REQUEST

Current Zoning: OFC (Office Flex Campus)
Proposed Zoning: RAC(CD) (Regional Activity Center, Conditional)

SUMMARY OF PETITION

PLANNING STAFF REVIEW

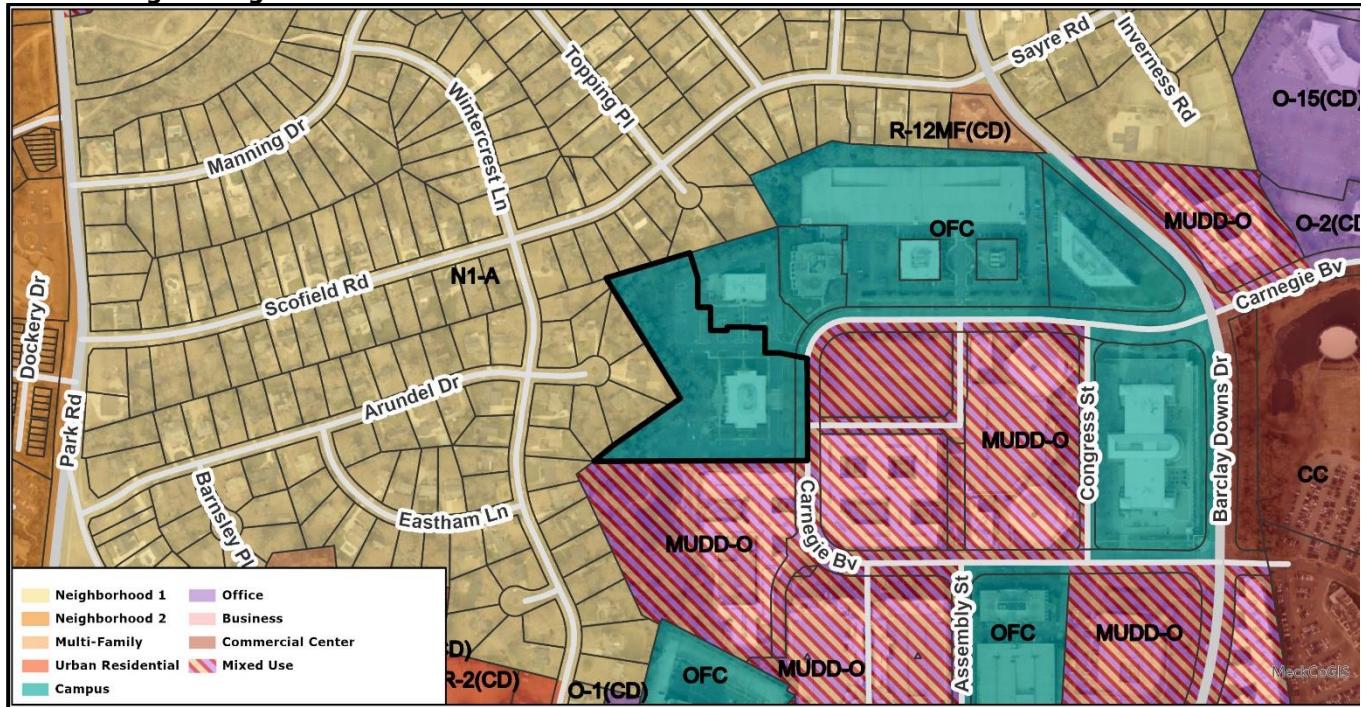
1. Site will trigger Tier 3 multimodal and TDM. Add conditional note that says, "Site will comply with CTR requirements to be finalized in permitting."

2. Please provide additional setback or increased landscape yards with a fence to adjacent to single-family.
3. Provide square footage of amenity area D.
